BULLETIN #2

DATE June 21, 2018

PROJECT NAME Saint Kenneth Catholic Church
Worship Space Addition & Renovation

PROJECT NUMBER 2014166

Scale: 1/4" = 1'-0"
Sheet
A601

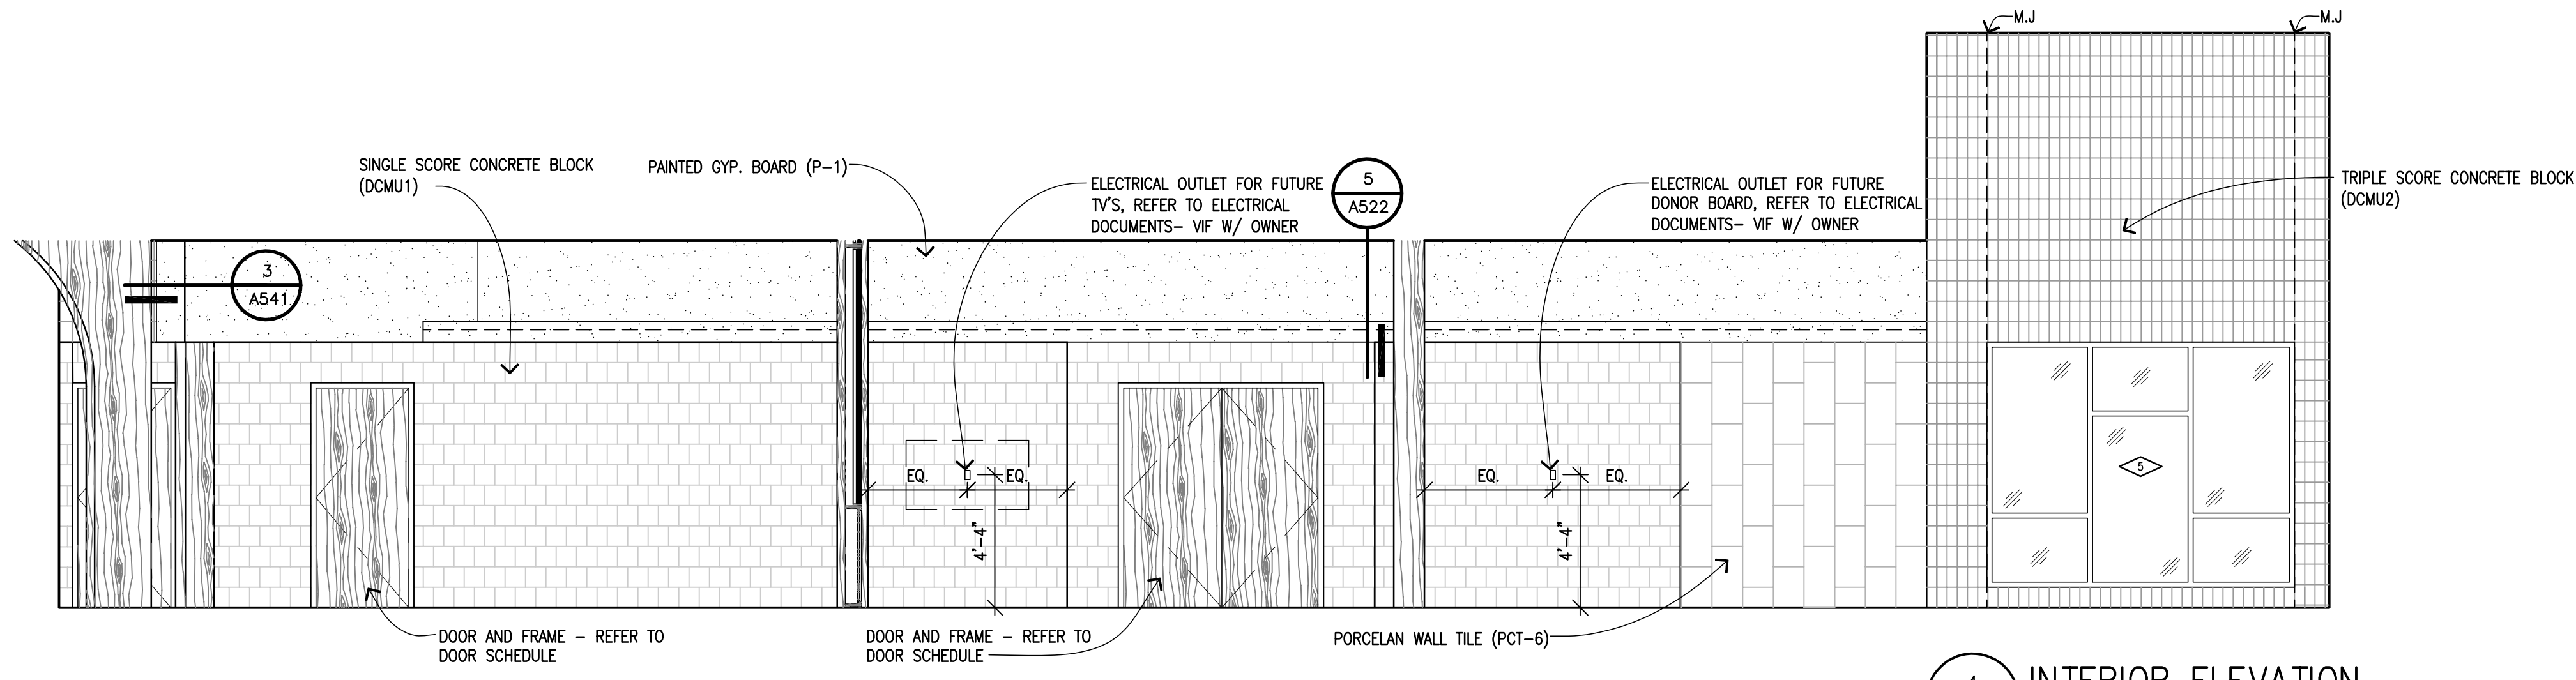
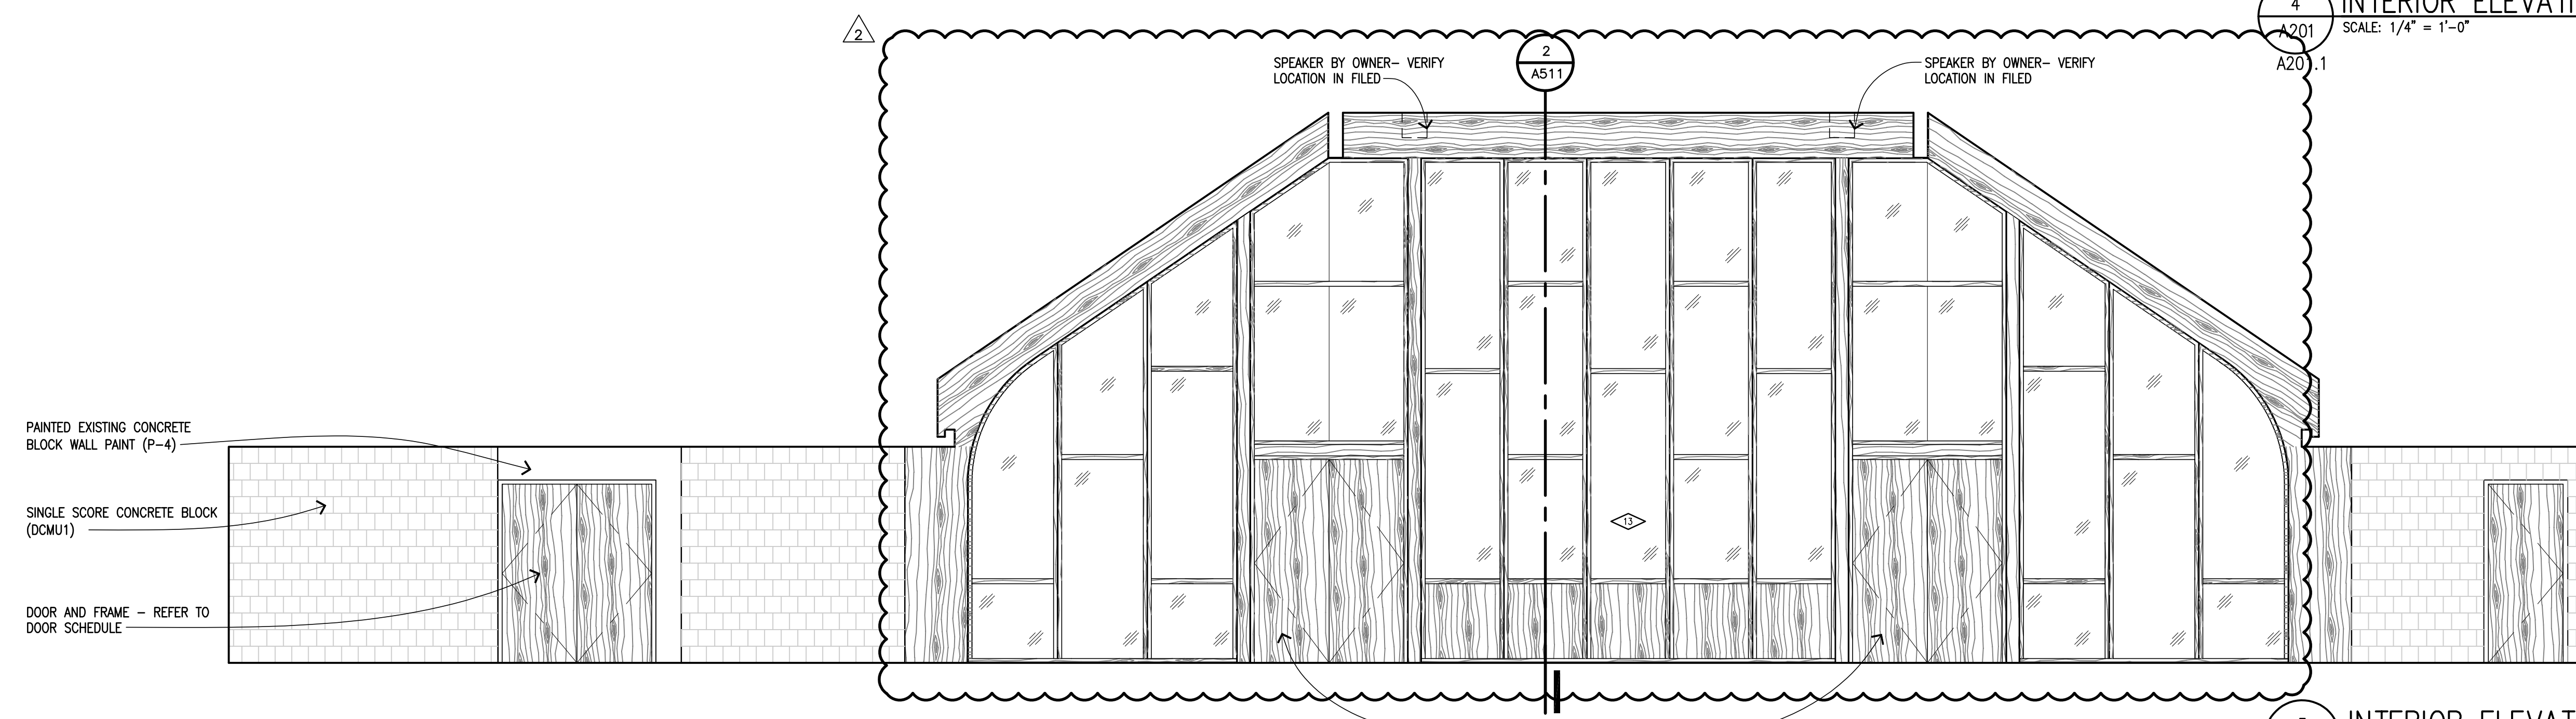
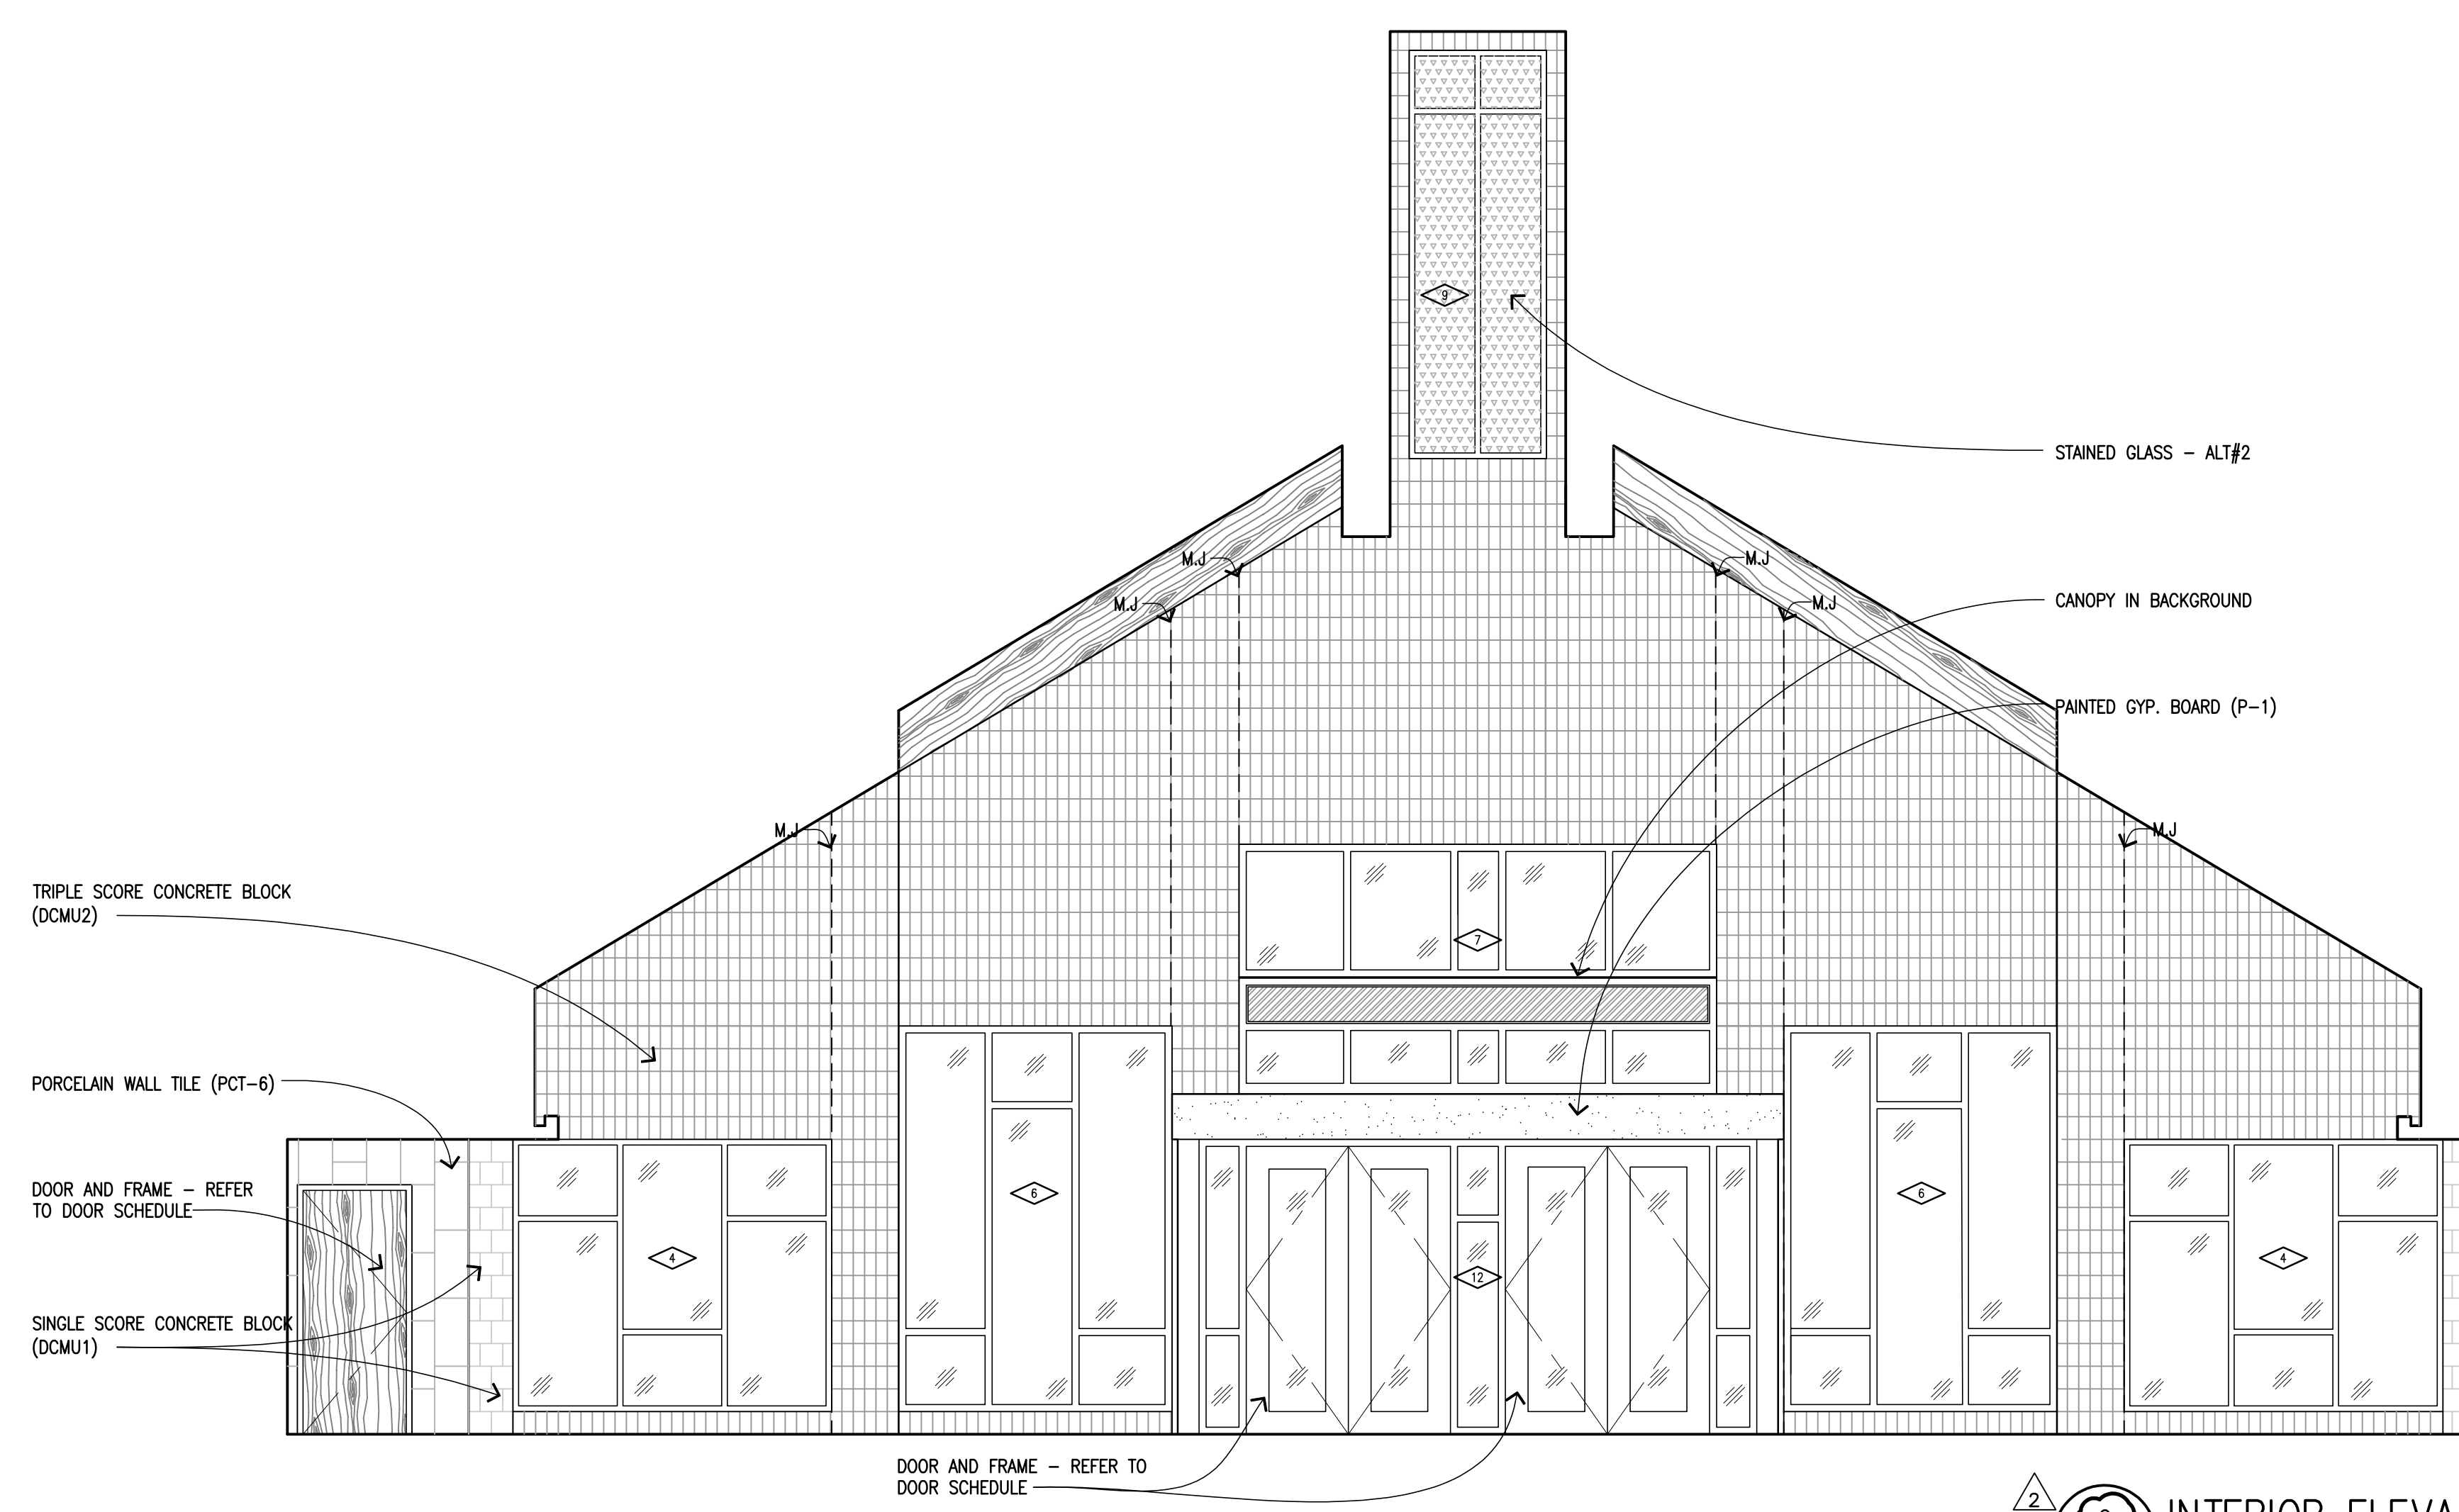
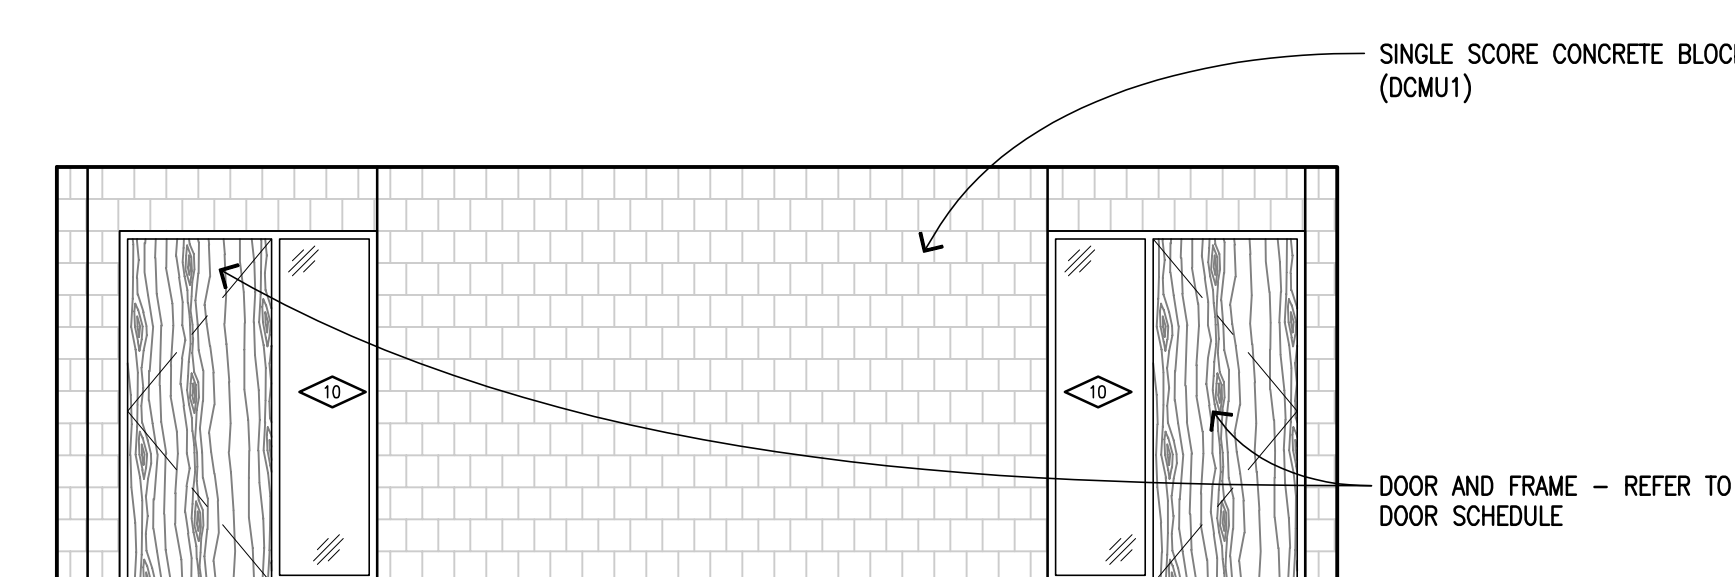
Item No. 1 – Wood Window System Exit Sign Details **Refer to Drawings A411, A571, A601, A901**

- A. Detail clarification showing conduit routing and installation of exit signs at doors 110A and 110B

- A. Updated opening in screen walls to coordinate with plan locations on A402.
- B. Additional dimensions provided on detail 14/A521
- C. Dimension clarification on wood window system on A411, and A601
